Access Compliance Report

Public Rights-of-Way

(Curb Ramps)

Intersection ID: 49150	Main Street: VIDAL_LN	Cross Street: DACAVIN_DR	Location: N
ADA ID: BBE6B3B085FC	Ramp Type: BlendTrans2	Initial Pass/Fail: Fail	Overall Compliance: No
		Severity Score: 33.75

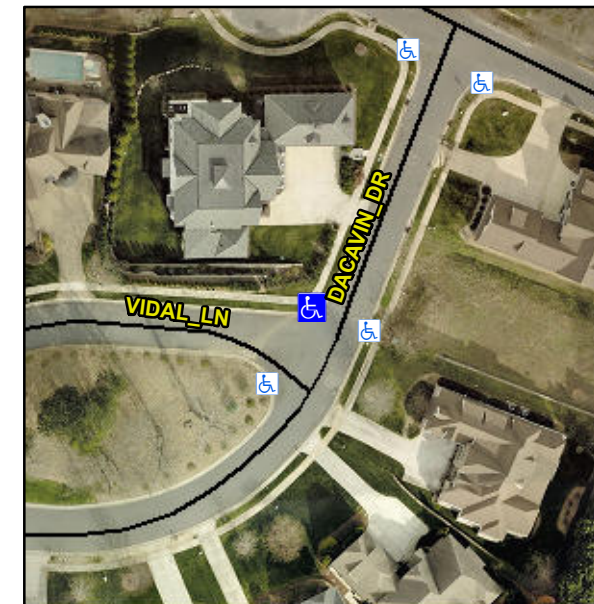
Not Found, R304.5.1, R304.5.3

Compliance	Description	Data	Compliance	Description	Data
N/A	Ramp Length (in)	95.0	Yes	BlendTrans Slope (%)	2.7
No	Ramp Width (in)	44.0	No	BlendTrans XSlope (%)	14.9
N/A	Flare Type LT	N/A	N/A	Flare Type RT	N/A
N/A	Flare Slope LT (%)	N/A	N/A	Flare Slope RT (%)	N/A
N/A	Flare Traversable LT?	N/A	N/A	Flare Traversable RT?	N/A
N/A	Landing Length (in)	N/A	N/A	DWS Provided?	N/A
N/A	Landing Width (in)	N/A	N/A	DWS Contrast?	N/A
N/A	Landing Slope (%)	N/A	N/A	DWS Length (in)	N/A
N/A	Landing X Slope (%)	N/A	N/A	DWS Full Width?	N/A
N/A	Landing Curb? (Y/N)	N/A	N/A	DWS Offset (in)	N/A
N/A	Shared Landing?	N/A			
N/A	Gutter Ponding?	N/A	N/A	Gutter Slope (%)	N/A
N/A	Gutter Lip Ht (in)	N/A	N/A	Gutter X Slope (%)	N/A
N/A	Painted X Walk1?	No	N/A	Painted X Walk2?	No
	X Walk 1 Direction	To SW		X Walk 2 Direction	To SE
	X Walk 1 Width (in)	N/A		X Walk 2 Width (in)	N/A
	X Walk 1 Slope (%)	11.9		X Walk 2 Slope (%)	1.4
	X Walk 1 X Slope (%)	1.6		X Walk 2 X Slope (%)	15.2

N/A	Ramp inside XWalk1?	N/A	N/A	Ramp inside XWalk2?	N/A
	Road Slope (%)	13.6		Clear Space?	N/A
	Road X Slope (%)	8.8	N/A	Clear Space to XWalk (in)	N/A
N/A	Any Obstructions?	N/A	N/A	Storm Grate/Utility Hazard?	N/A
	Obstruction Type			Storm Grate/Utility Type	
		N/A			N/A
			Yes	Surface Condition? (G/P)	Good
			No	Curb Slope (%)	6.0

Possible Solutions:

Remove & Replace Curb Ramp With Two New Directional Ramps or Equivalent.
